**SAN ANTONIO WATER SYSTEM**  
**NORTHEAST SERVICE CENTER – PARKING LOT ADDITION**

**SAWS JOB NUMBER #12-7701**  
**SAWS SOLICITATION #B-12-038-DD**

**ADDENDUM NO. 1**  
**June 22, 2012**

**E-03**  
Sheet Number

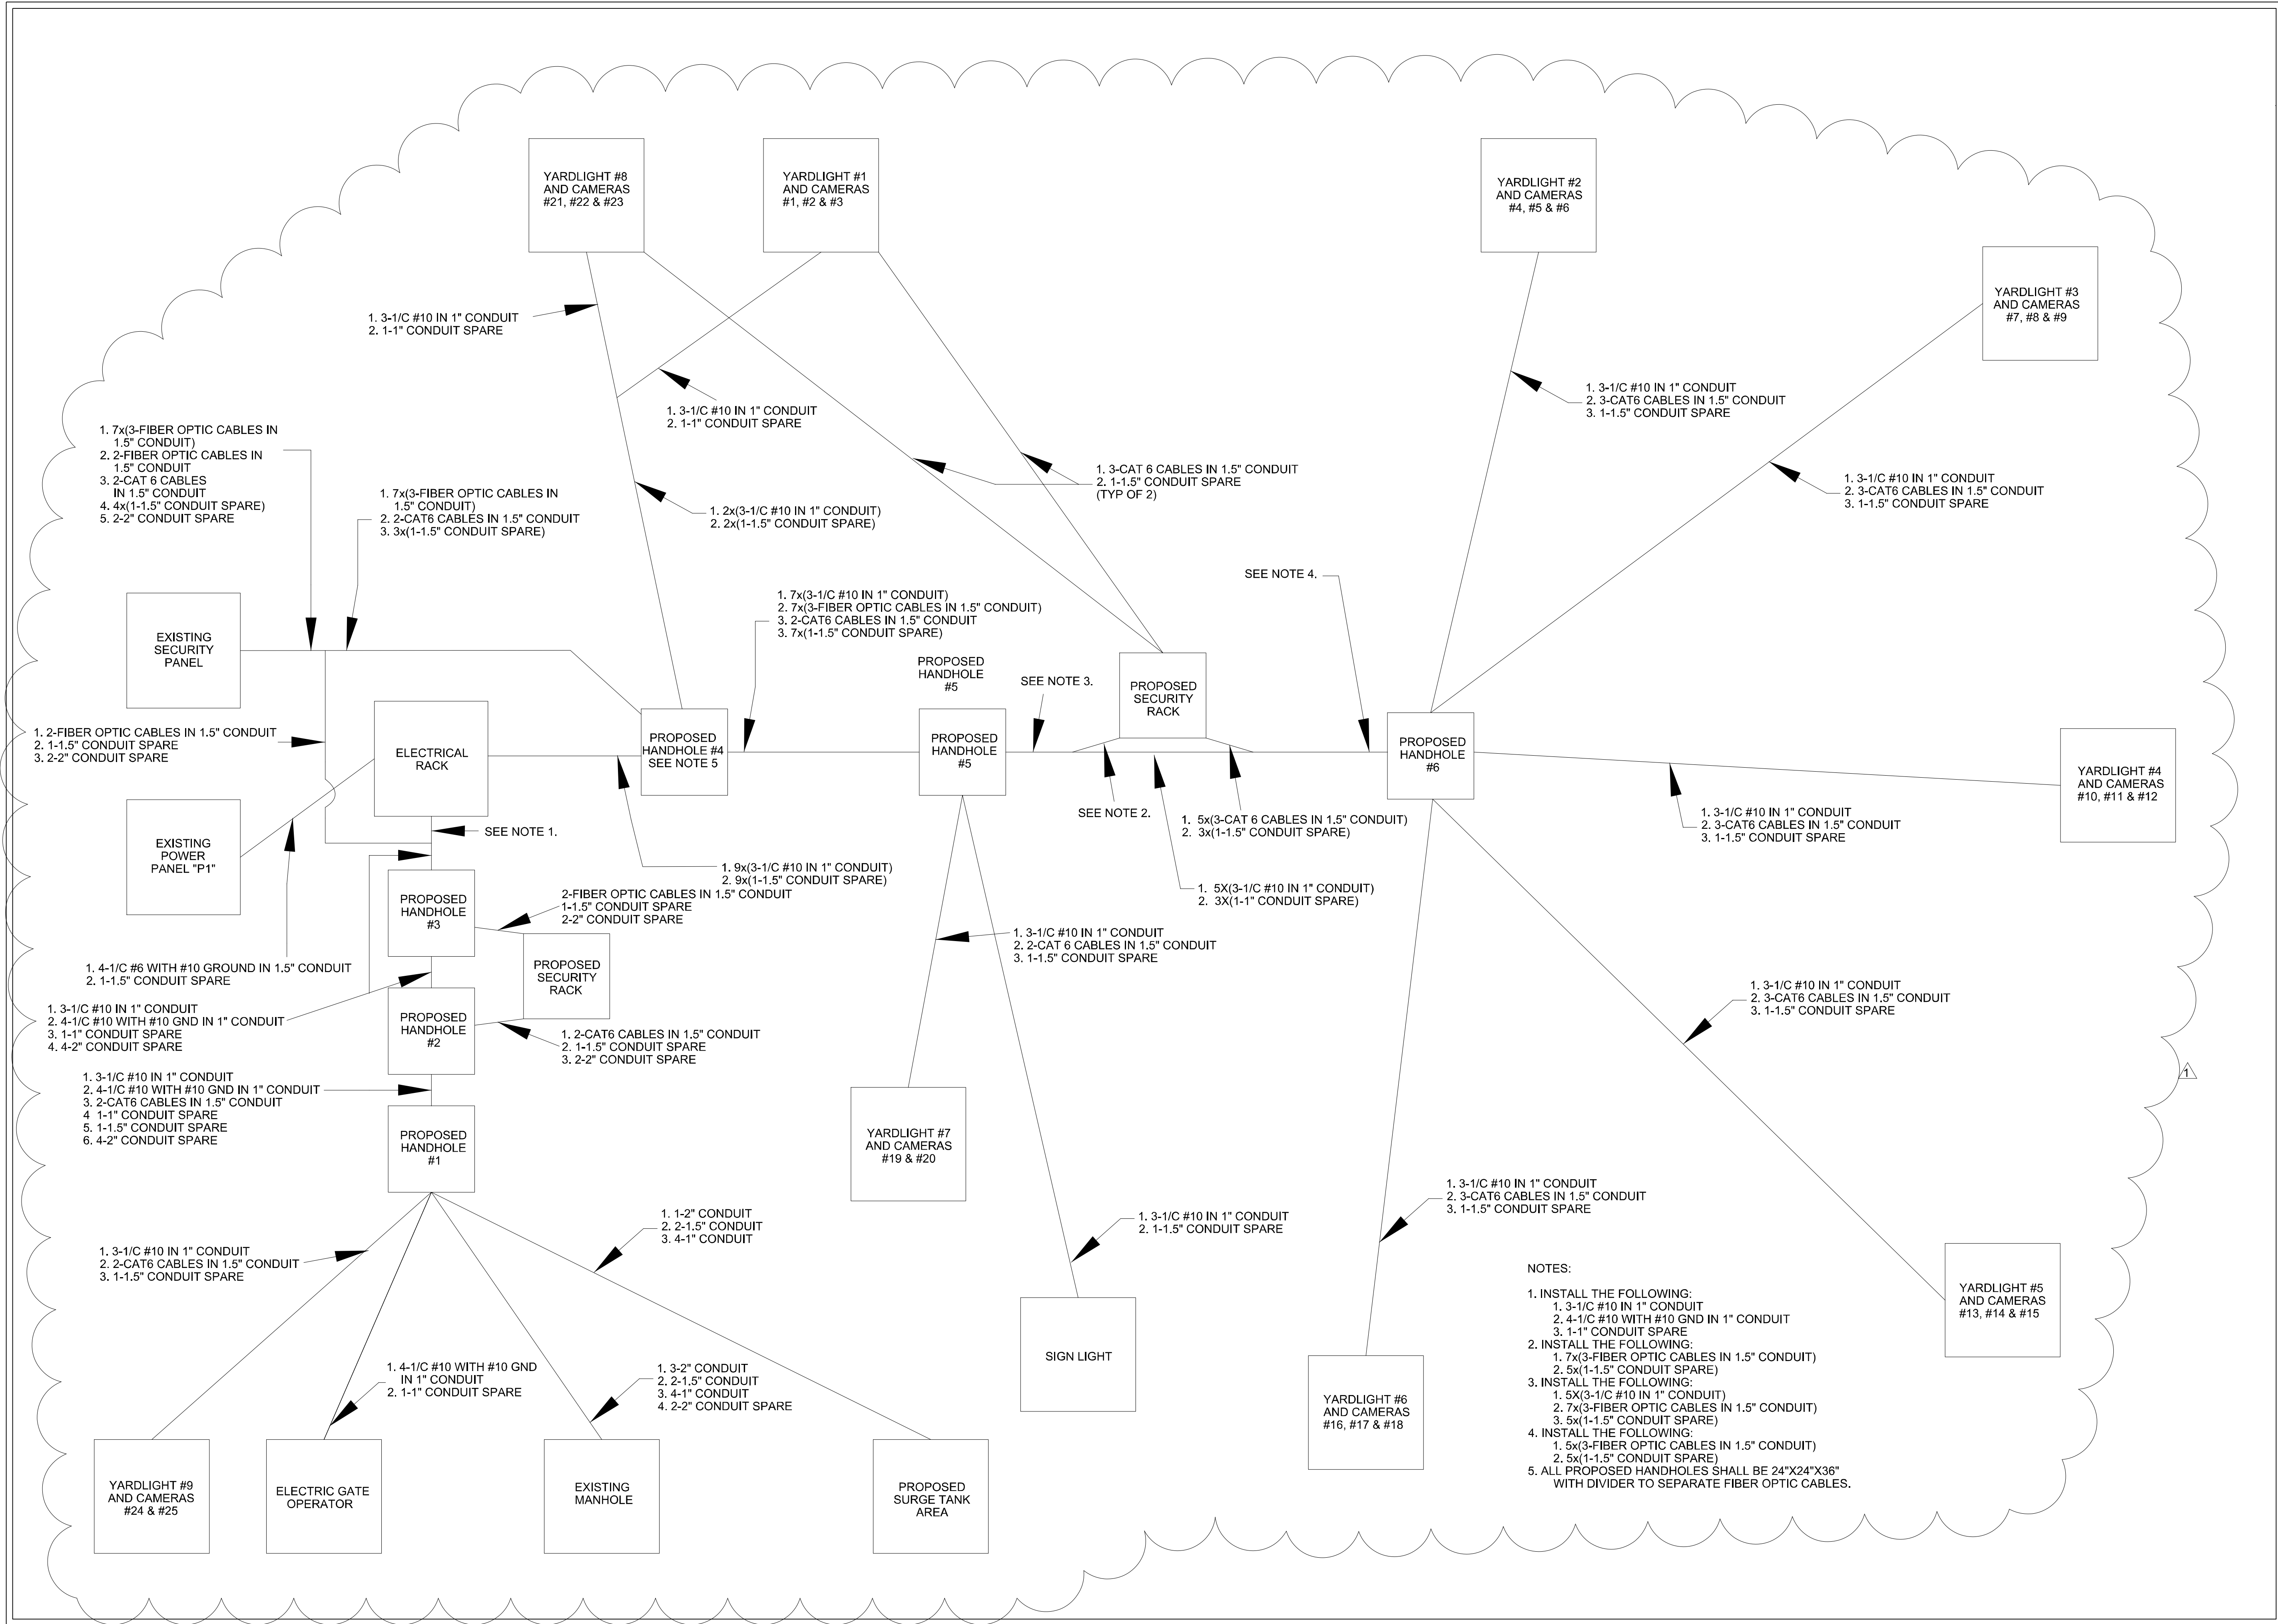
## **Sheet E-03**

**“Revised security system diagram”**
